HISTORIC AND DESIGN REVIEW COMMISSION

HDRC CASE NO: 2022-293
ADDRESS: 1024 N CHERRY
LEGAL DESCRIPTION: NCB 512 BLK 25 LOT W 99.55 FT OF 3
ZONING: R-4, H
CITY COUNCIL DIST.: 2
DISTRICT: Dignowity Hill Historic District
APPLICANT: Joseph Munoz
OWNER: Joseph Munoz
TYPE OF WORK: Construction of a rear addition, exterior modifications, fenestration modifications, porch modifications, roof form modifications, window replacement and siding modifications
APPLICATION RECEIVED: July 27, 2022
60-DAY REVIEW: Not applicable due to City Council Emergency Orders
CASE MANAGER: Edward Hall

Historic and Design Review Commission
Design Review Committee Report

ROOF PLAN
SCALE: 1/4" = 1'

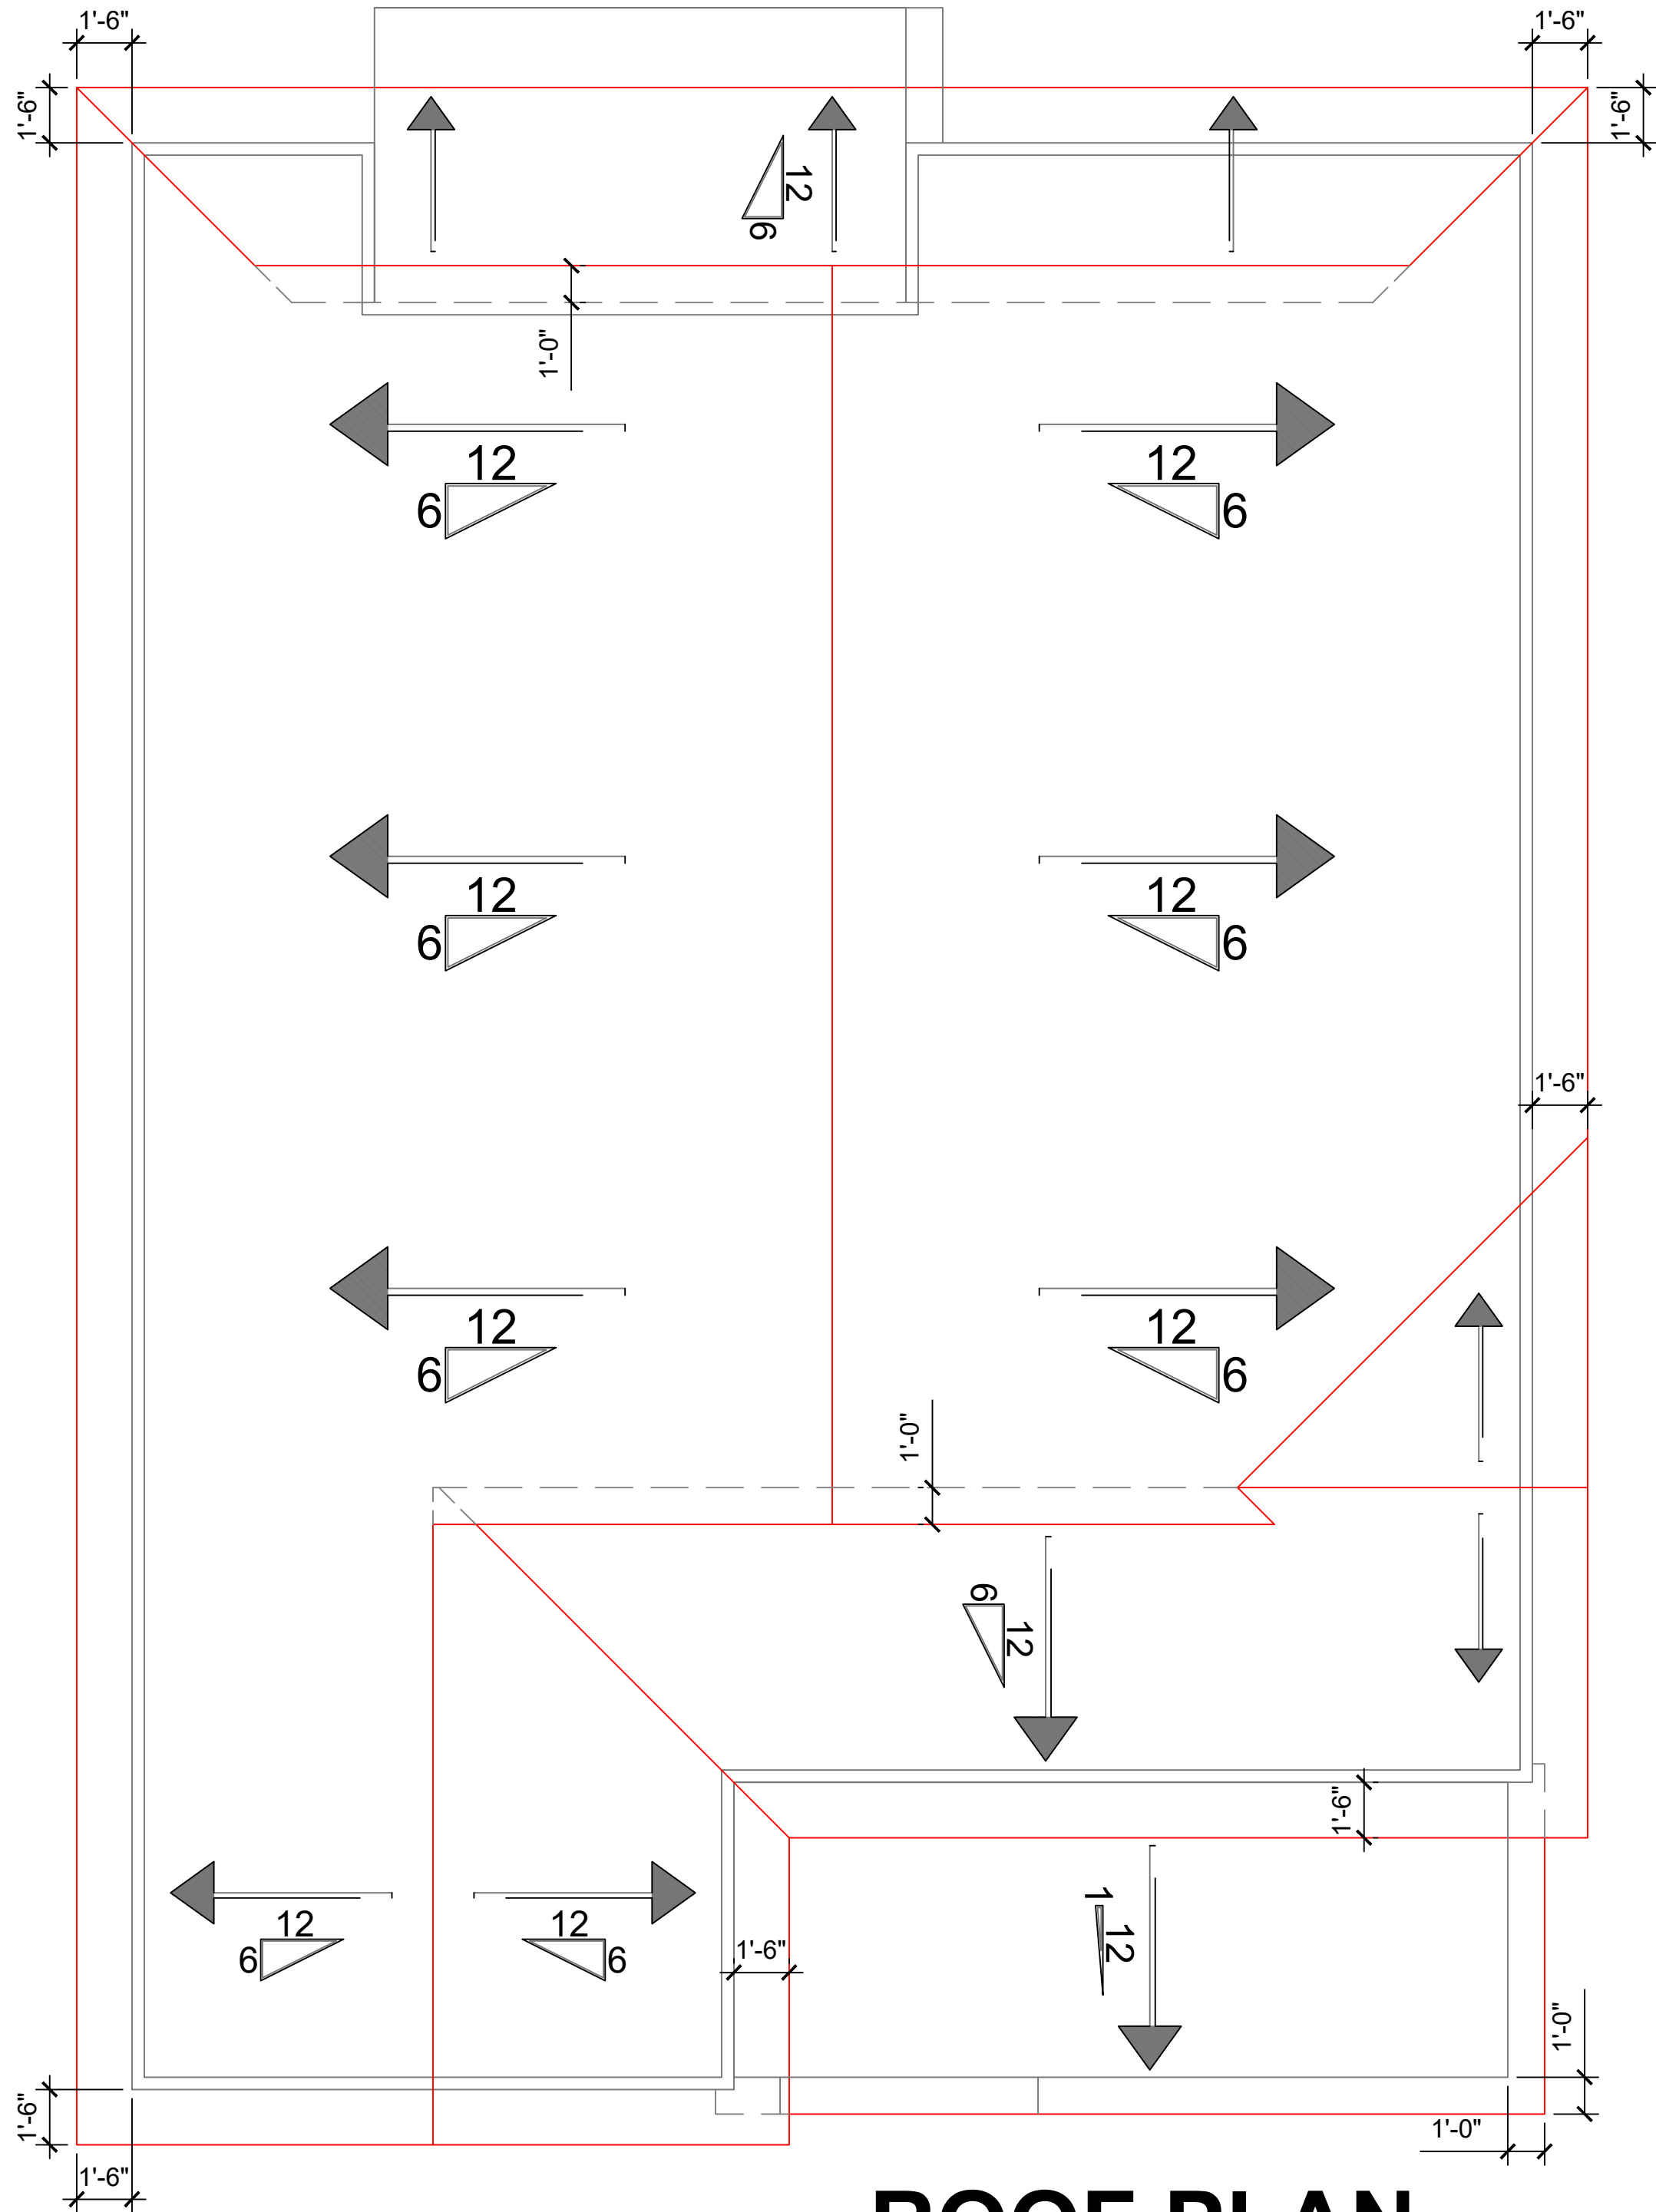
- h. ROOF FORM MODIFICATIONS – The applicant has proposed to modify the structure's roof form and various architectural elements that are associated with the roof that include eave details, the installation of gable returns, modifications to existing attic vents. The Guidelines for Exterior Maintenance 3.B.ii. notes that the original shape, line, pitch, and overhangs of original roof forms should be preserved. Additionally, eaves and other decorative elements should be preserved. The proposed modifications are inappropriate and consistent with the Guidelines. Staff finds that the original roof forms and attic vents should be reinstalled.

- m. REAR ADDITION (Materials) – The applicant has proposed materials for the rear addition that include composite siding, a shingle roof, and aluminum windows.
- n. ROOF FORM – The applicant has proposed for the rear addition to feature a roof that features a front facing gable and a rear gable/hip combination. The proposed roof form features a profile and overall height that are greater than that of the historic structure, resulting in a front facing gable that rises above the historic structure's ridge line. Staff finds the proposed roof form to be inappropriate and inconsistent with the Guidelines.
- o. ARCHITECTURAL DETAILS – As noted in findings i through l, staff finds that there are numerous items that are not consistent with the Guidelines, including the proposed addition's massing, roof form and materials.

4. Staff does not recommend approval of item #4, modifications to the historic structure's roof form based on finding f. Staff recommends that the original roof forms and attic vents be reinstalled.
